**TELEFAX****AMENDMENTS TO THE DRAWINGS**

**09/767,362**

FIG. 1

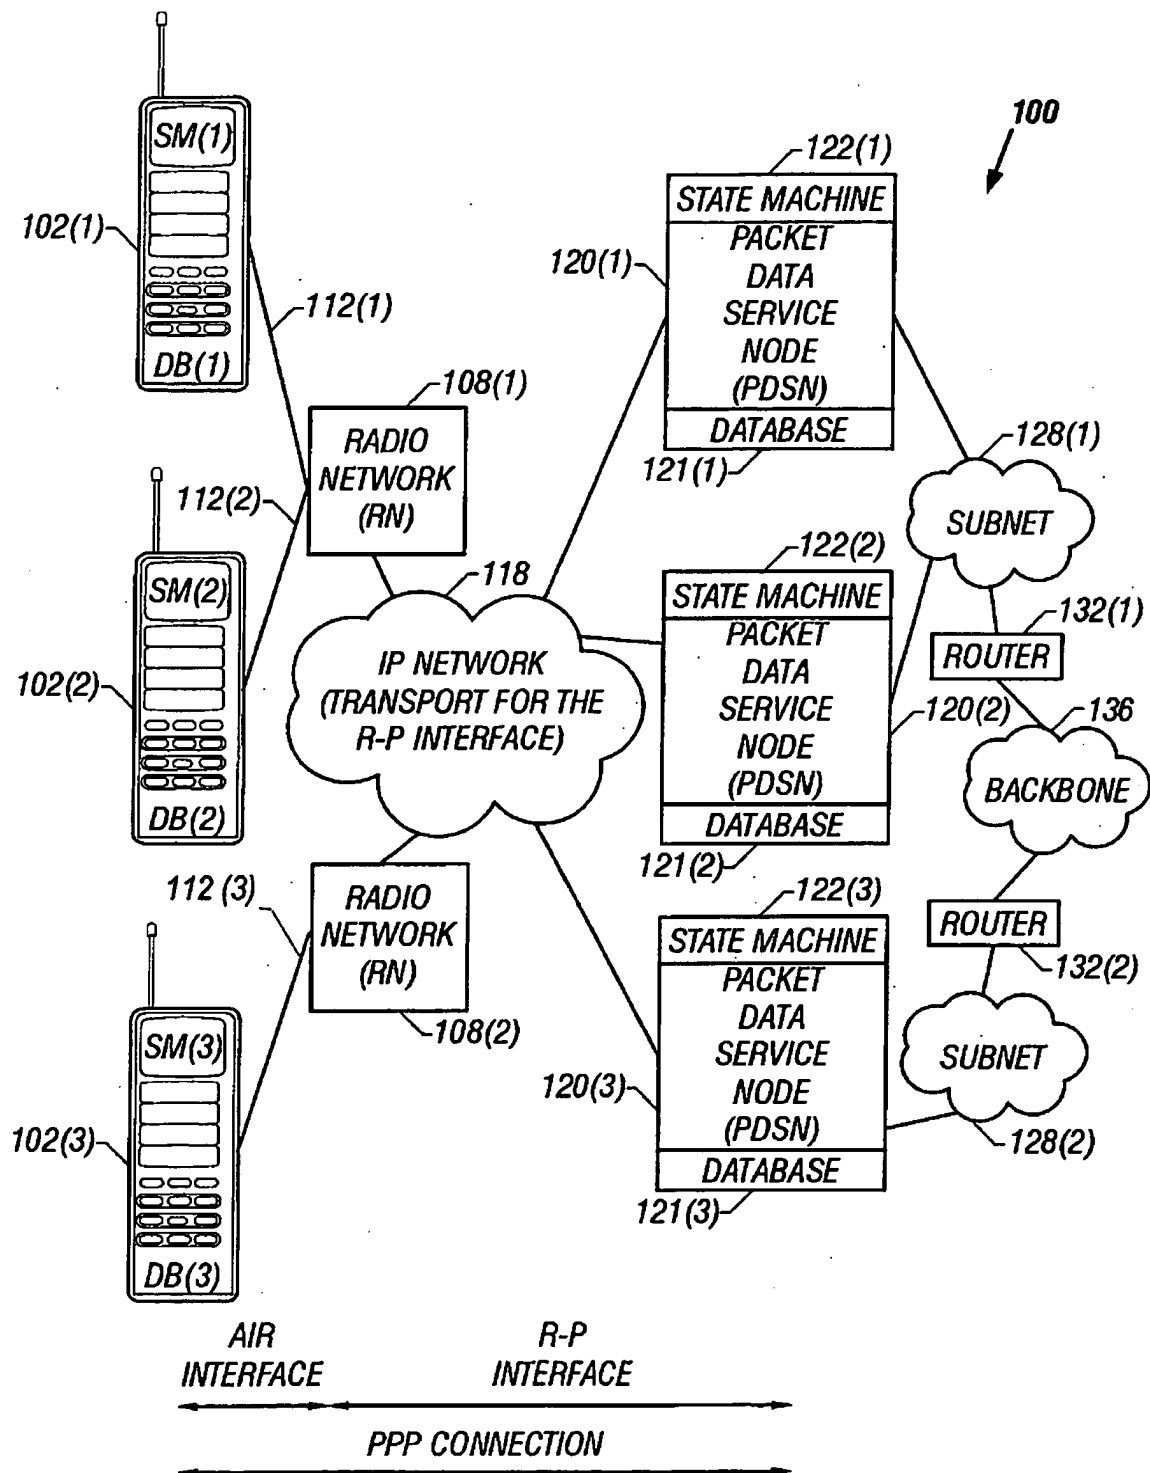
In paragraph 1 of his report, the Examiner objected to the drawings because they fail to show the air interface number 112 (3). For that reason, Applicants submit amended Figure 1, which does not include new material. Amended Figure 1 merely corrects a clerical error. In particular, the interface number 112 (3) and item 112 (3) are described in the Specification, but were missing on original Figure 1. The amended Figure 1 is included herewith on Replacement Sheet.
